BTeV IP Review

December 18, 2003

A review of the BTeV Interaction Point design was held on October 7, 2003. The Review committee consisted of Terry Anderson, Alexei Burov (absent), Bruce Hanna, John Johnstone, Mike Martens, Mike McGee, Nikolai Mokhov, King-Yuen Ng, Rob Roser, and Mike Syphers (chair). The presentations were well prepared and very enlightening to the reviewers, most of whom were not familiar with the BTeV project. The main issues presented and discussed during the review were: (a) vacuum, (b) impedance, (c) aperture and operations, and (d) radiation environment. Below we present, for each issue, bullets from the Review Close-out presented by Syphers, followed in each case by subsequent comments and questions from the other reviewers. (All reviewers responded with comments; extensive comments received are presented and duplications avoided where possible.) Also included are recent responses or comments to some of the more outstanding issues, many of which have been compiled by Peter Garbincius. The Charge to the Committee can be found at the end of the document.

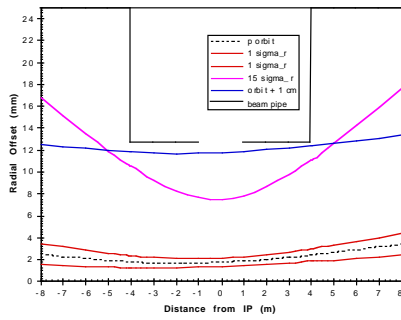
From my own calculations, I can assert that with low-beta IR optics there are no aperture conflicts throughout the C0 region at any energy and for any operational mode. (Pictures are attached below.)

At injection the nearest approach to the aperture limits occur at the D/S end of the 1" pipe. With Yuri's preferred "5-star" helix solution the "orbit+1cm" case narrowly clears the beam pipe wall.

During C0 collisions 15-sigma is just 0.6 mm at the IP so bringing the silicon wafers as close as 4 mm to the beam shouldn't be an issue for the Tevatron.

150 GeV Injection Clearance @ C0
 $\beta^* = 3.50 \text{ m}$ & $\mathcal{E} = 20 \mu\text{m}$

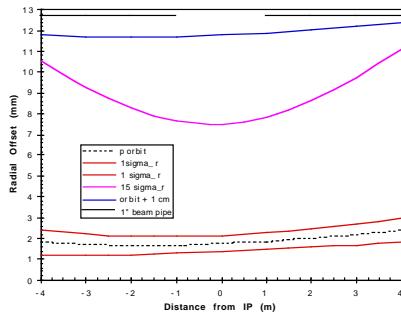
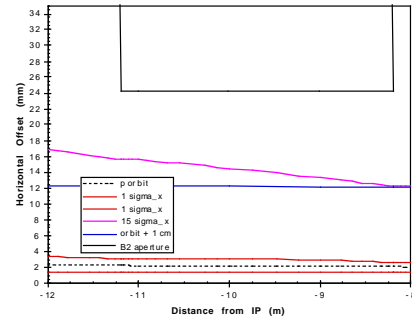
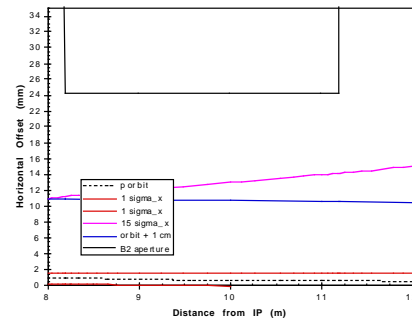
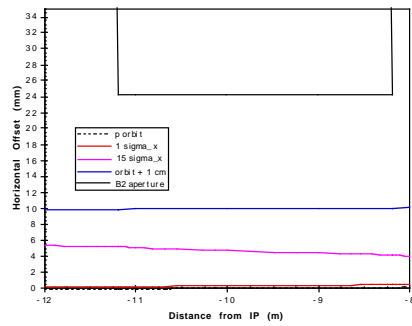
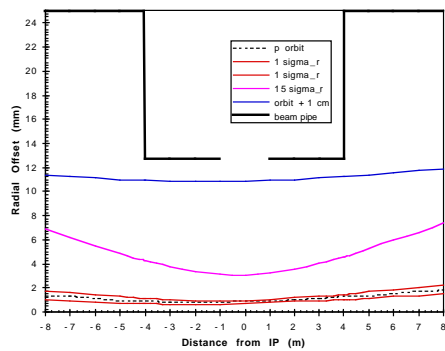
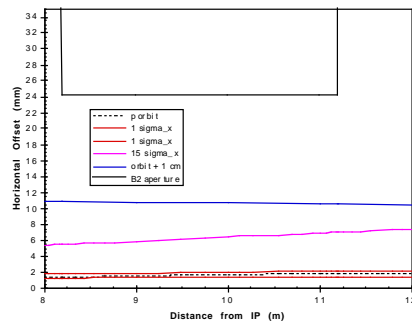
During injection, with Collins optics, the 2" pipe accepts an aperture criteria of 8-9 sigma. The "orbit+1cm" envelope fits comfortably within the pipe, with clearance > 8 mm everywhere in both planes. Horizontally, the "x-orbit+10-sigma-x" fits as far as 8 m D/S of the IP. This should be sufficient and, without the compensating B2 at this spot, it may be that the 2" pipe could become a standard 3". (Pictures of the calculated injection vertical & horizontal apertures are attached below).
